Access Compliance Report

Public Rights-of-Way

(Island Curb Cuts)

| Intersection ID: 6957 | Main Street: N_TRYON_ST | Cross Street: N_US_29_BY-PASS_HY | Location: N |

| ADA ID: 59D952D9EA87 | Curb Cut Type: MedianRefuge2 | Initial Pass/Fail: Fail | Overall Compliance: No |

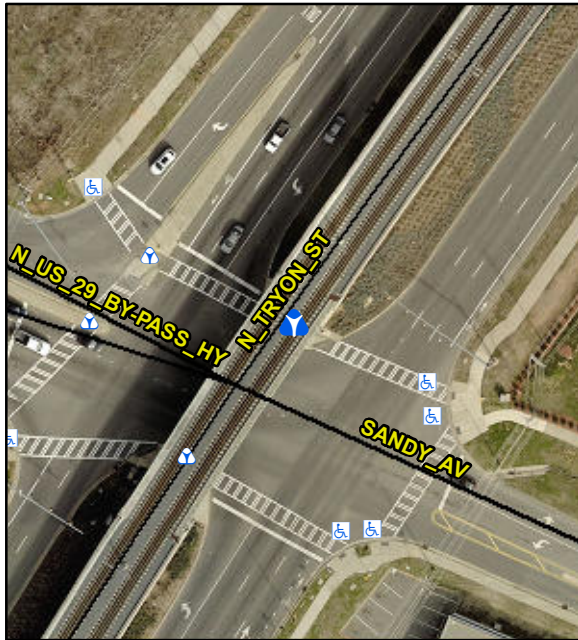
| Severity Score: 1.25 | | | |

Possible Solutions:

Remove & Replace Entire Refuge.
